Subject: Sequoyah Fuels Corporation, Docket – 40-8027
Response to Request For Additional Information – Reclamation
Plan – Ground Water Protection (TAC L52511)

Enclosure 1
Sequoyah Fuels Corporation
Response to Request for Additional Information
Reclamation Plan Review
Ground Water Protection

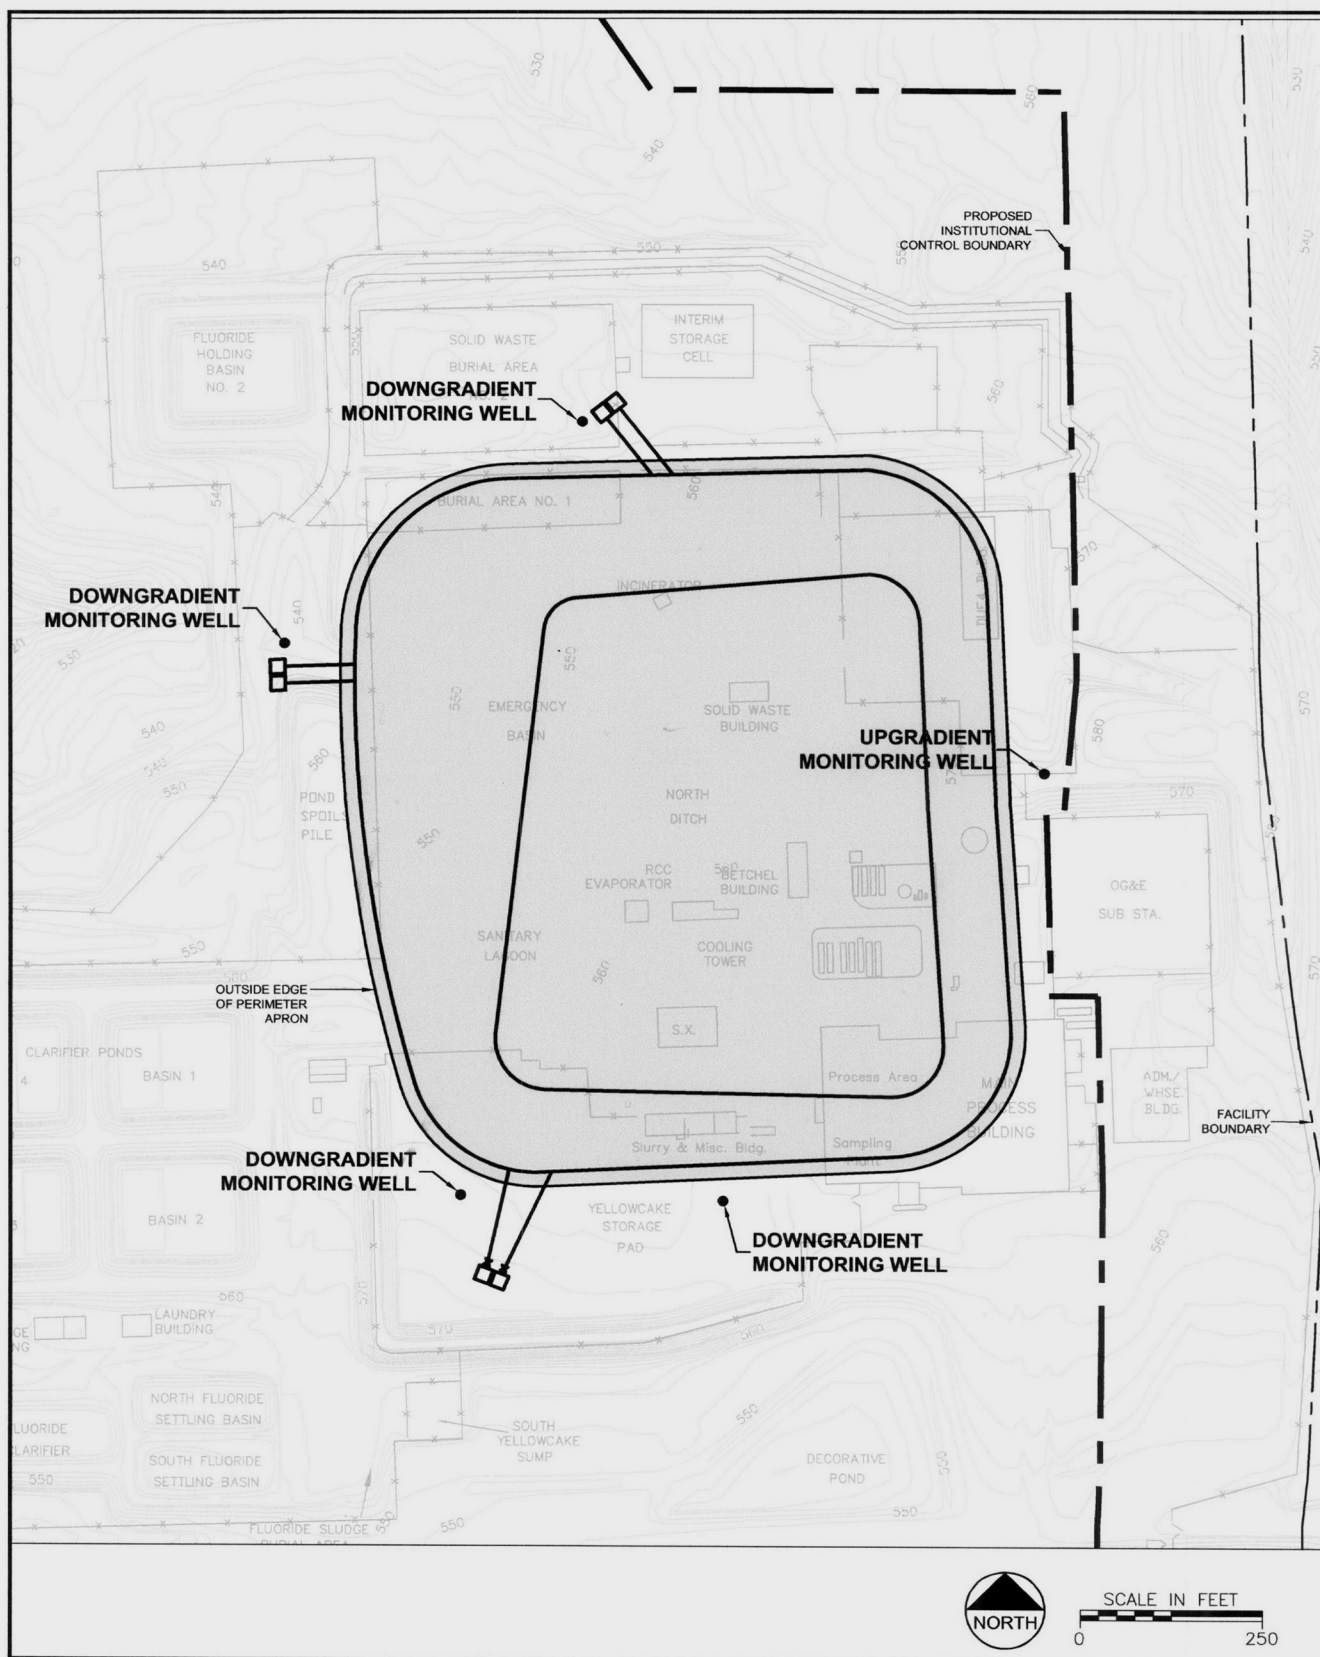
- A** **REQUEST:** A discrepancy exists between the written geologic descriptions and associated maps contained in Appendix D. Page 3-14 states that Sandstone 1 underlies the Terrace Groundwater System; however, cross-sections contained in Figure 11, Appendix D, and in Figure 14 of the Reclamation Plan show that Shale 1 underlies the Terrace system. Please clarify this discrepancy.

There have been numerous conceptual groundwater models used at the site over the last 15 to 20 years. Each of these site models have referred to the geologic conditions in a slightly different manner. The use of similar terminology to represent slightly different geologic layers has caused some confusion. The current site model is the most comprehensive and has divided the groundwater system into the discrete geologic units that exist at the site. That conceptual model is described in the Hydrogeological and Geochemical Site Characterization Report (HGSCR) (Appendix B of the Reclamation Plan).

The term Terrace Groundwater System, as discussed in the request above, refers to the uppermost interconnected aquifer system that is comprised of the upper terrace soils and Shale 1. The Terrace Groundwater System is perched on top of Sandstone 1.

FIGURE 1
CELL MONITORING WELLS

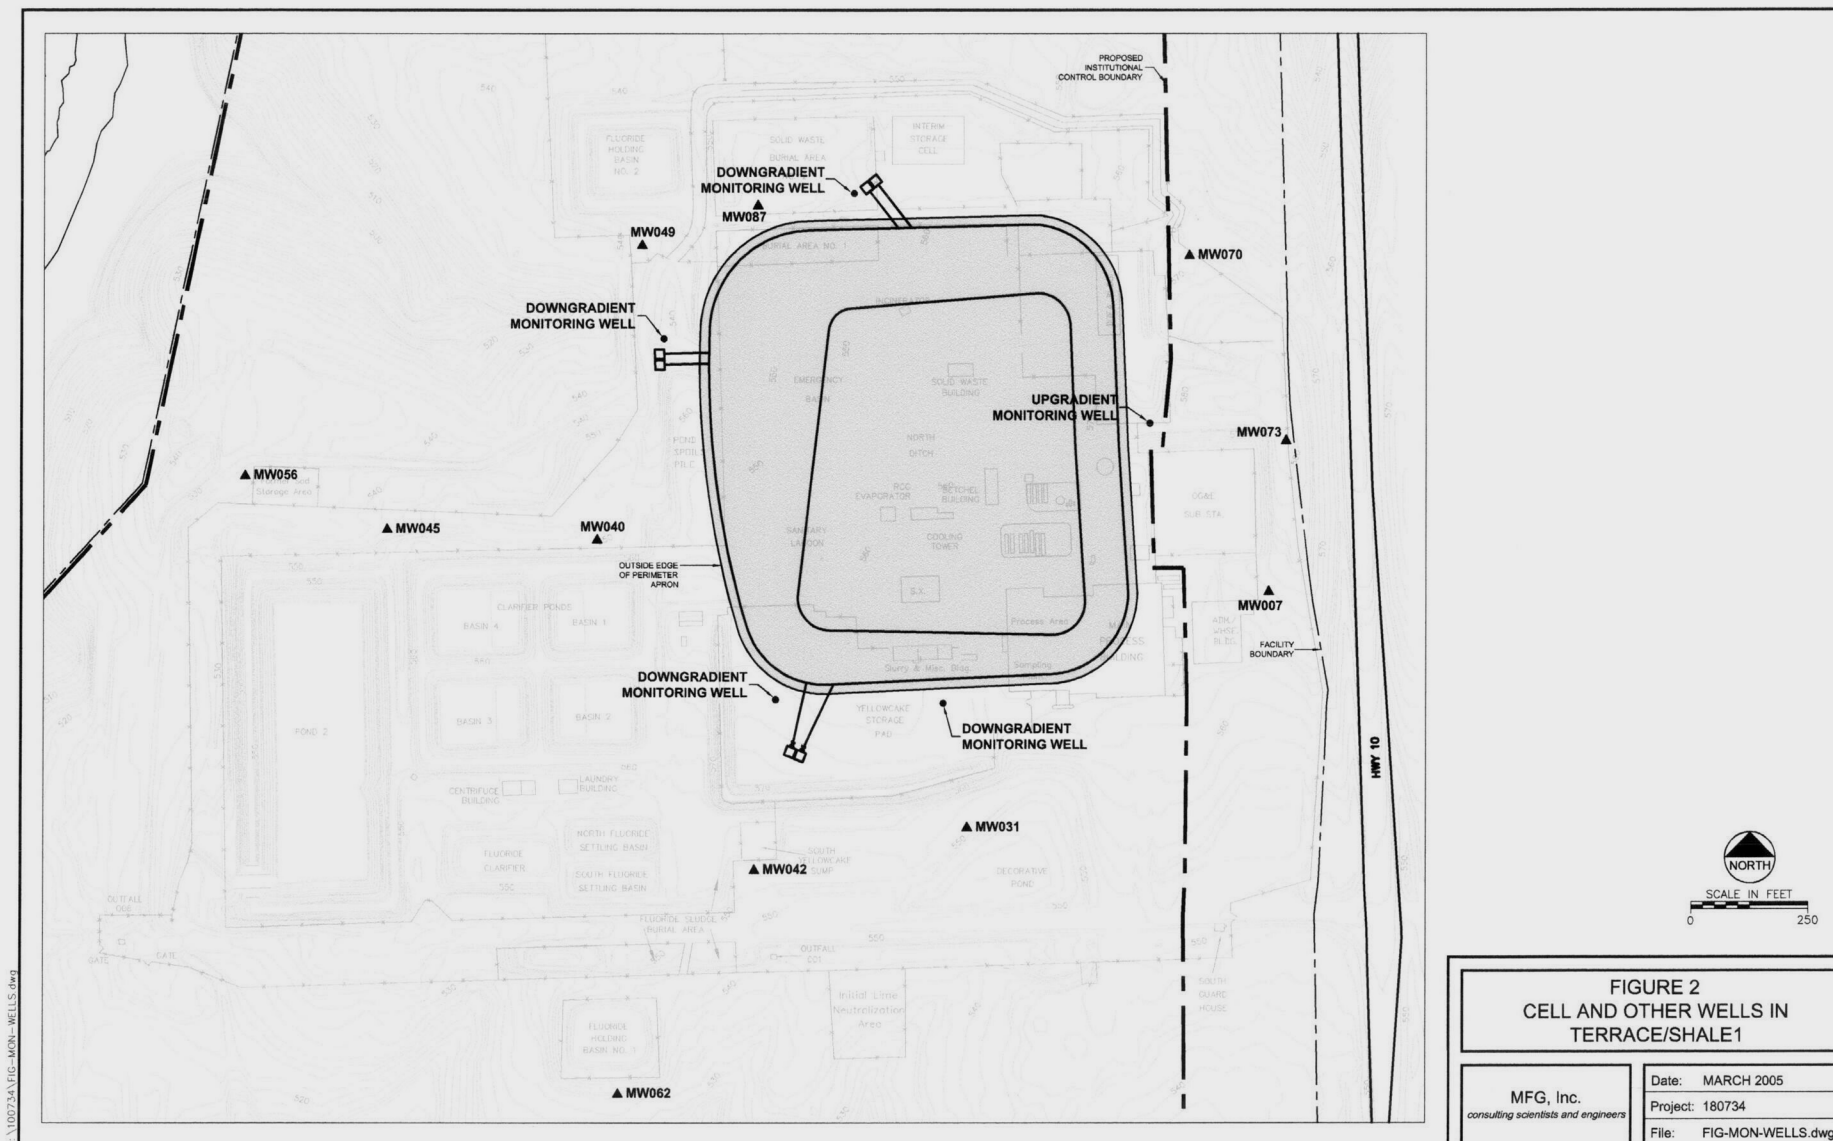
- B** **REQUEST:** Section 7.0, Attachment E of the Reclamation Plan indicates that three point of compliance (POC) wells are proposed for the disposal cell monitoring network. Such a network assumes that ground water gradients will remain largely unaffected by the presence of an above ground disposal cell. However, topographic alterations, such as

disposal cells, can cause localized changes in groundwater gradients because of the higher total hydraulic head in the disposal cover. Such conditions could cause ground water to migrate radially away from the disposal cell for a certain distance before being overcome by the regional groundwater gradient. Therefore, SFC should propose additional POC wells along the disposal cell circumference or provide justification that the three proposed wells will provide sufficient coverage after the disposal cell is built.

There are five proposed wells to monitor groundwater from the cell. The location of these wells is illustrated on Figure 1 and shown on the design drawings for the cell. The wells have been located based on the site specific geohydrologic conditions. Specifically, one well is located east of the cell which is up-gradient, while the other four wells are located west, north-west, south-west and south of the cell. These four directions are down-gradient from the cell.

Given the nature of the cell and the local hydrologic conditions, the five proposed wells, in conjunction with the monitoring program detailed above, will be sufficient to provide leak detection monitoring.
